LAND USE APPLICATION SUMMARY

Property Location: 2018, 2022, and 2024 Aldrich Avenue N; 715 21st Avenue N
Project Name: Sanctuary Covenant Church
Prepared By: Mei-Ling Smith, City Planner, (612) 673-5342
Applicant: Nicole Thompson and Tom Peterson, Station I9 Architects, Inc.
Project Contact: Nicole Thompson and Tom Peterson, Station I9 Architects, Inc.
Request: To use an existing building as a place of assembly and to construct a 15,600 square foot addition.

Variance	To reduce the minimum loading requirement from one to zero.
Site Plan Review	For a 15,600 square foot addition to an existing building.

SITE DIMENSION PLAN
 SANCTUARY COVENANT CHURCH
 CITY OF MINNEAPOLIS

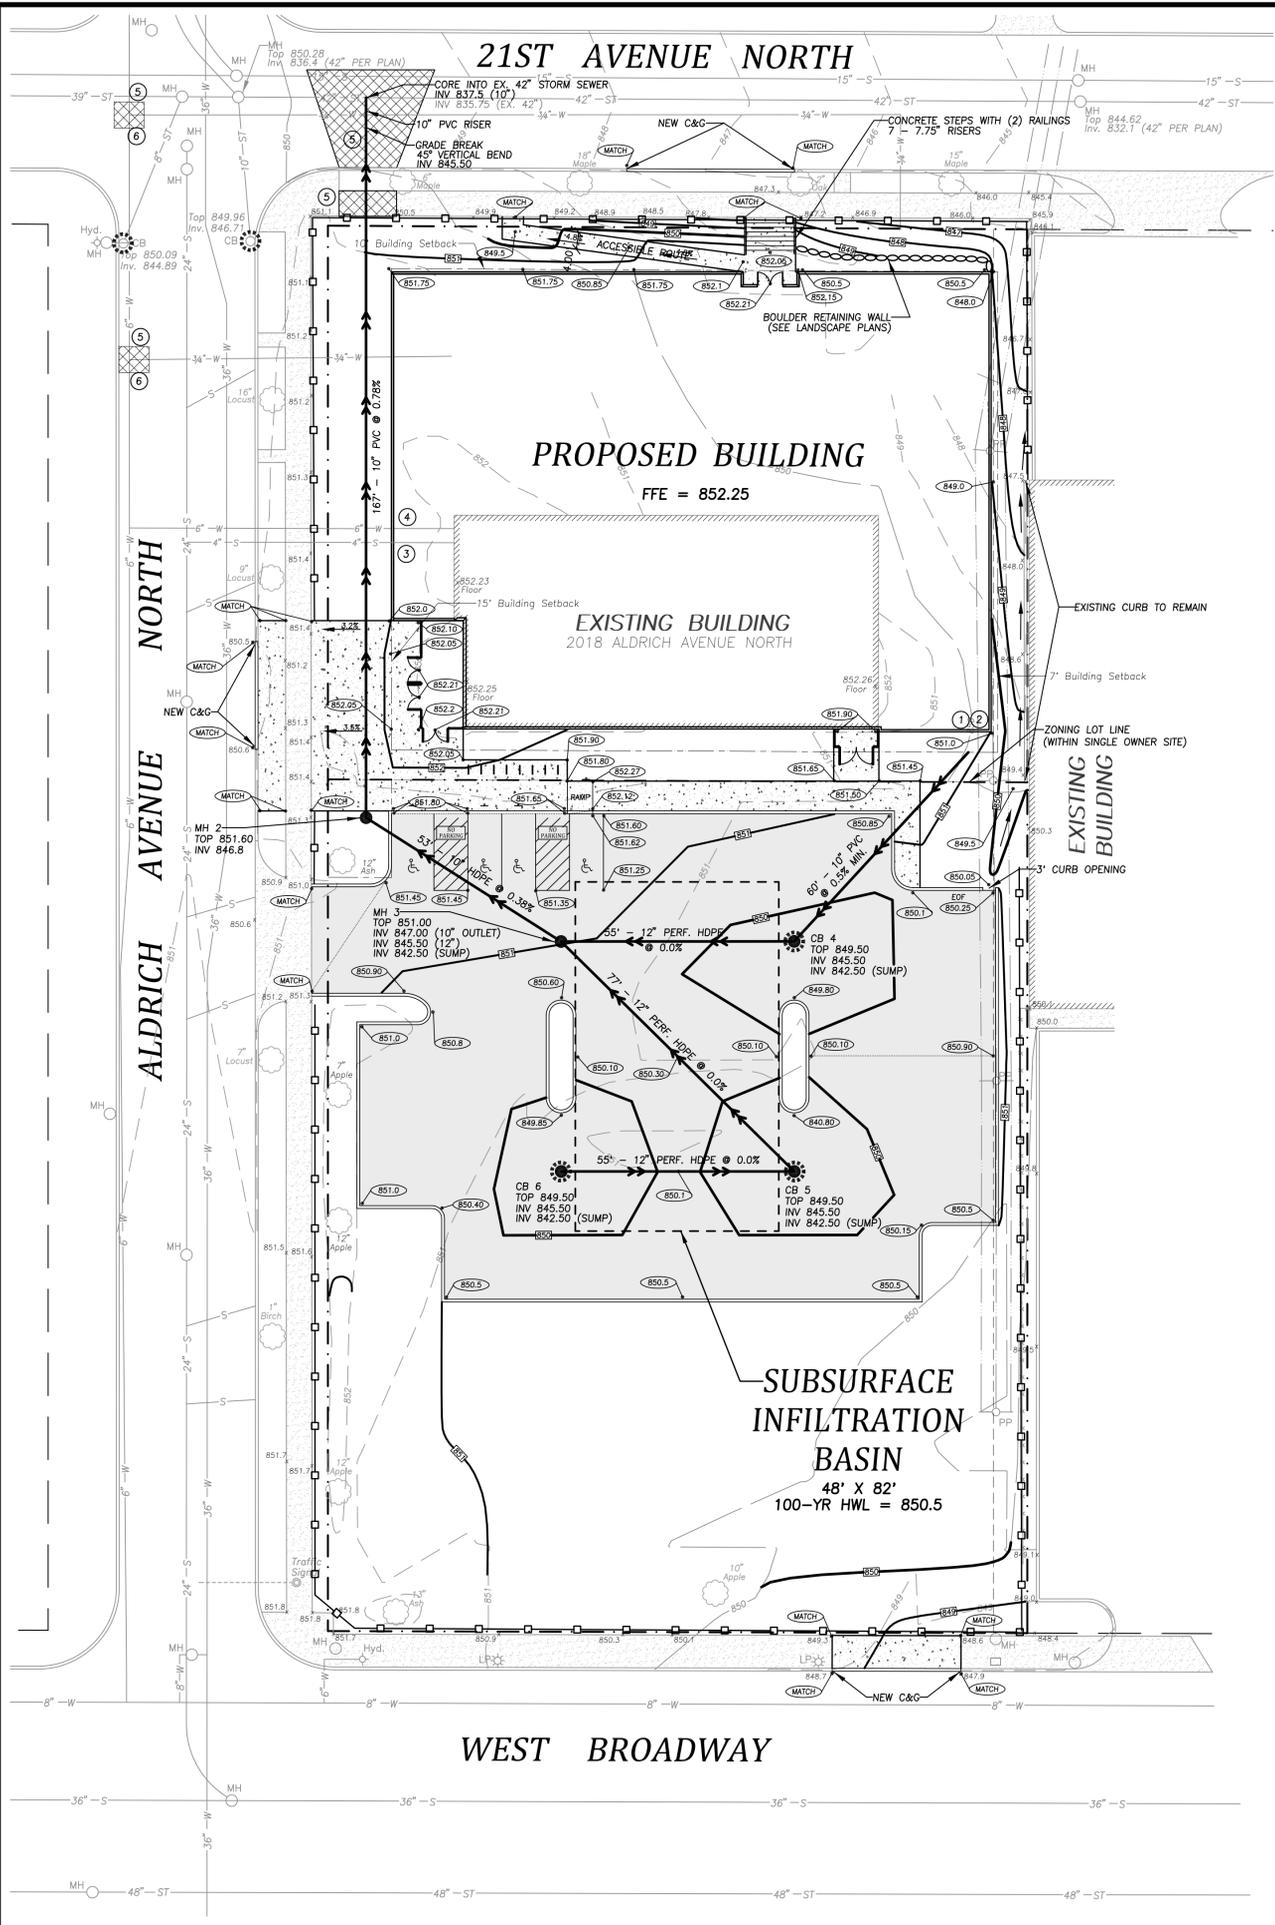
- The proposed development complies with all minimum building setback requirements (see Table 10)
- The walkway connecting the entrance facing Aldrich Avenue N to the public sidewalk exceeds 12 feet in width, which is the maximum width for a walkway for an institutional use in a required yard. Staff is recommending a condition of approval that requires that the final plans be amended to show a maximum width of 12 feet for any walkway in a required yard.

7. The final landscaping plan shall include no fewer than three on-site canopy trees, as required by section 530.160 of the zoning code.
8. The final plans shall be amended to show a maximum width of 12 feet for any walkway in a required yard.

GRADING, DRAINAGE & UTILITY PLAN
SANCTUARY COVENANT CHURCH
CITY OF MINNEAPOLIS

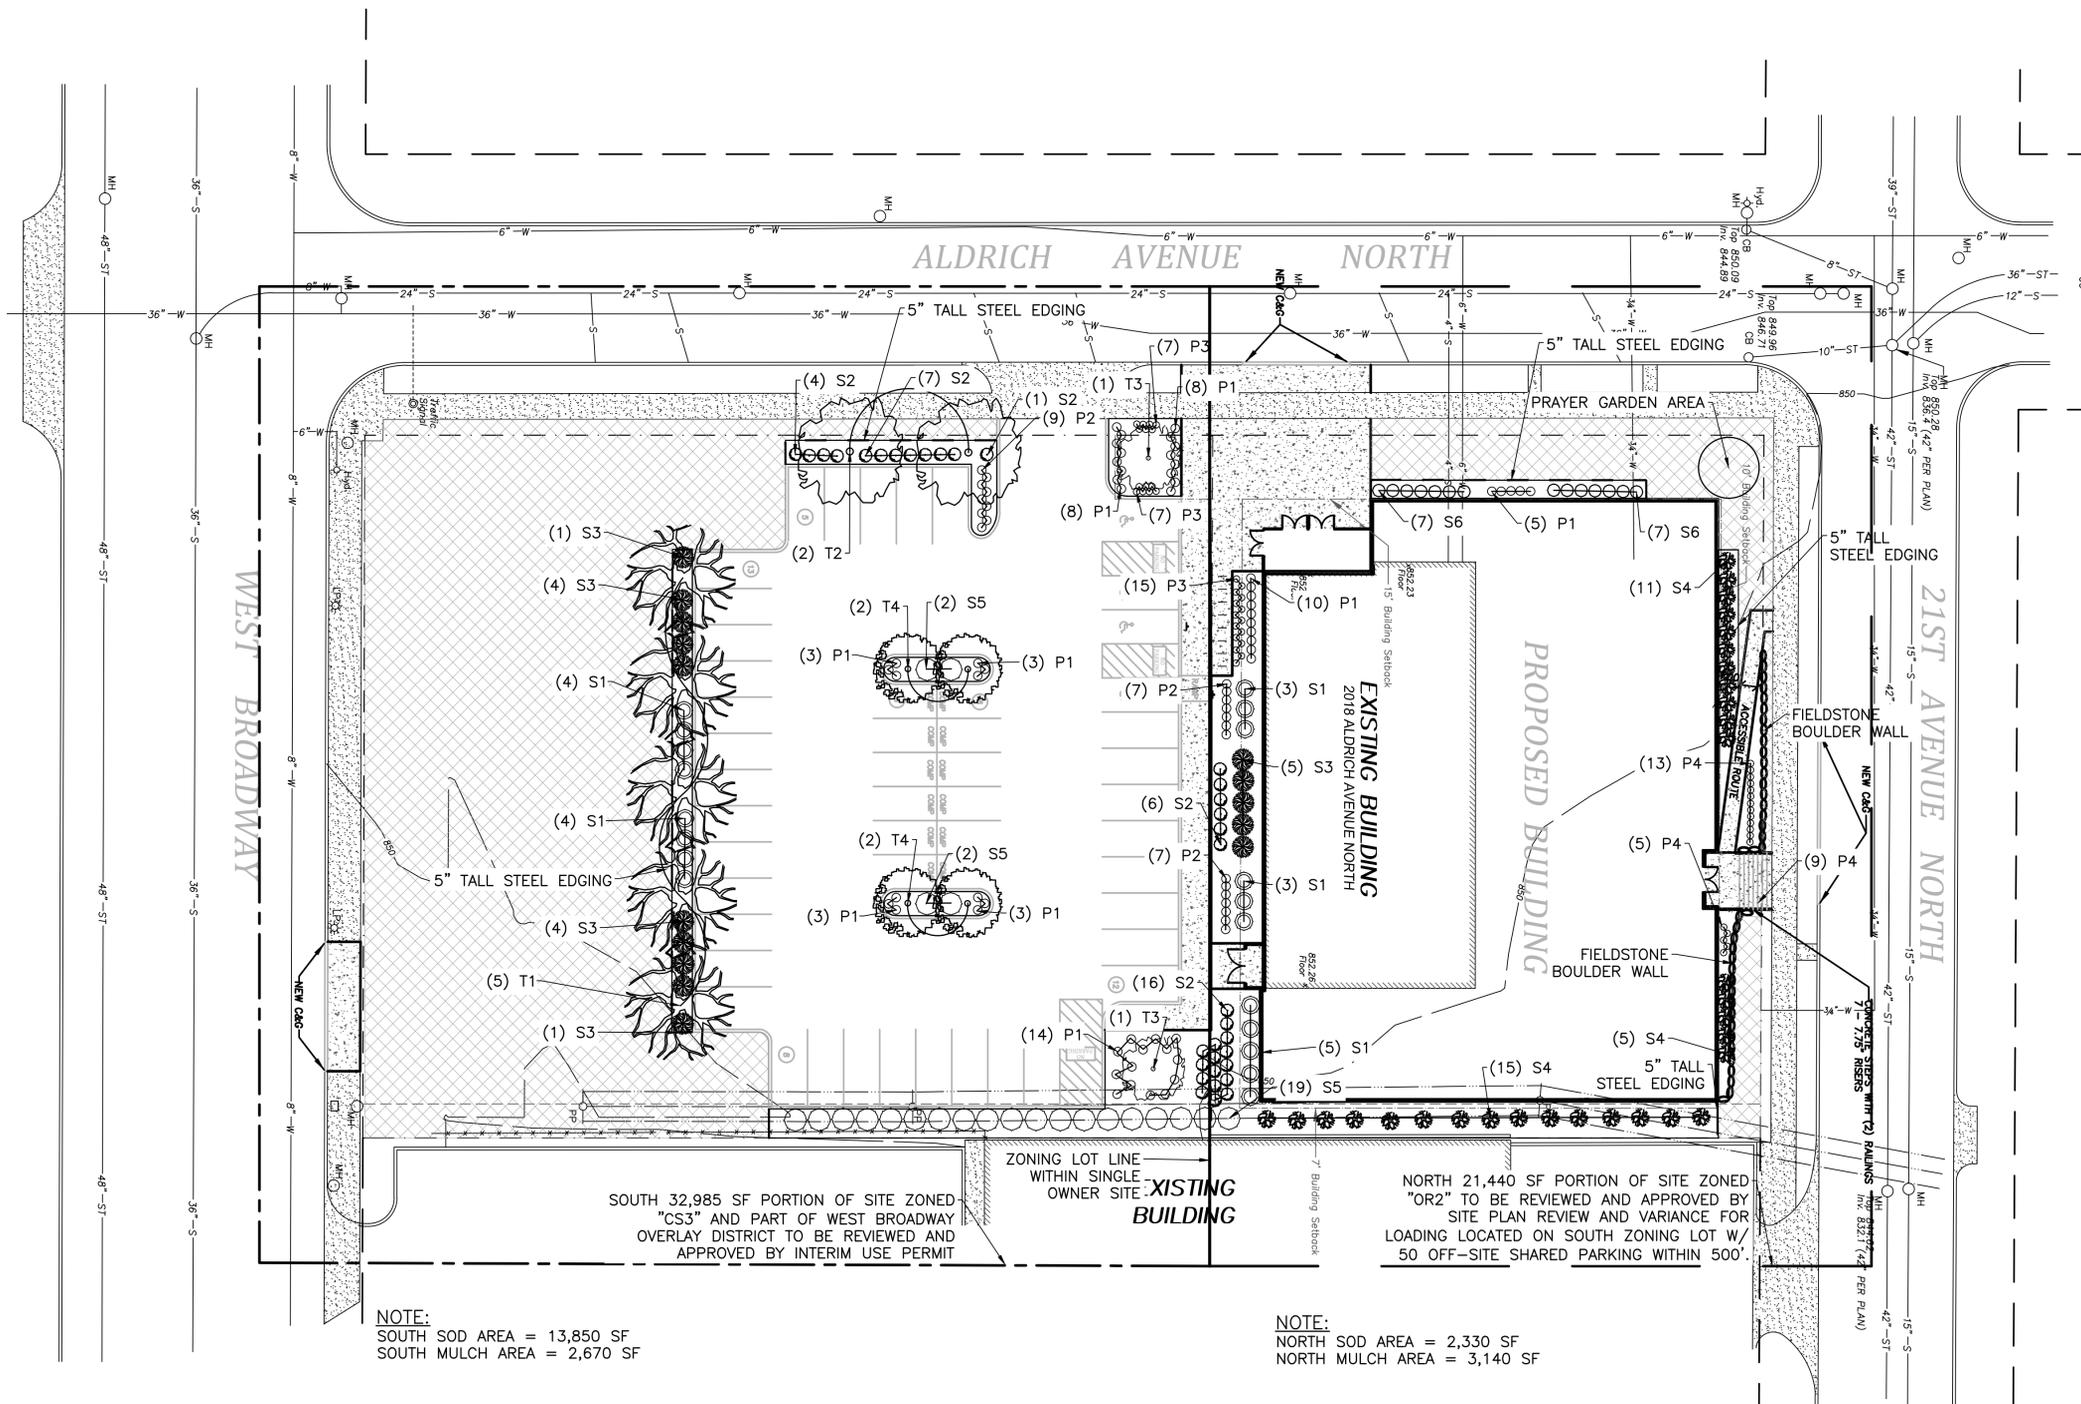
- Stormwater Management: Please provide documentation that the 70% TSS removal requirement is being met for the site. The MIDS calculator provided does not appear to account for the entire site.

- It is recommended that larger perforated pipes for the subsurface infiltration be considered. There is likely little cost difference between 12" HDPE and larger HDPE pipes, to an extent; whereas the 1.5" clear granite, trap, or quartz called for in the detail is likely somewhat costly. The less of this being used, with larger pipes, may be of benefit.

- Utility Connections: The proposed storm sewer connection to the City catch basin is not permitted. Private connections must occur at the main. The proposed 10" storm connection may be core drilled into the 42" storm main with a saddle tee fitting installed. Please revise the plans accordingly.
